PRODUCT / PROCESS CHANGE INFORMATION

1.1 Company		STMicroelectronics International N.V
1.2 PCI No.	MDG/19/11504	
1.3 Title of PCI	ST Shenzhen (China) additional source of Carrier Tape and Cover Tape for TSSOP 20 package products	
1.4 Product Category	All products in TSSOP20L from ST Shenzhen	
1.5 Issue date	2019-06-07

ST Shenzhen (China)
**additional source of Carrier Tape and Cover Tape
for TSSOP 20 package products**

Current source	Added source
CARRIER TAPE	3M	CPAK
COVER TAPE	3M	CPAK

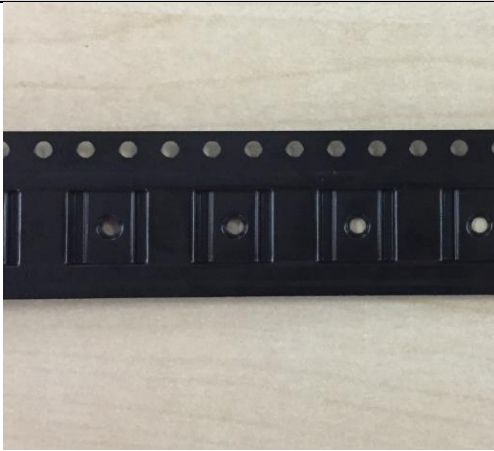
What are the changes?

Changes described in the below table:

No FIT change, no need to change manufacturing set-up at customer premises.
Dimension remains within spec and follows international standards EIA 481 (US) / IEC 60286-3 (EU).

No functional change, No quality difference
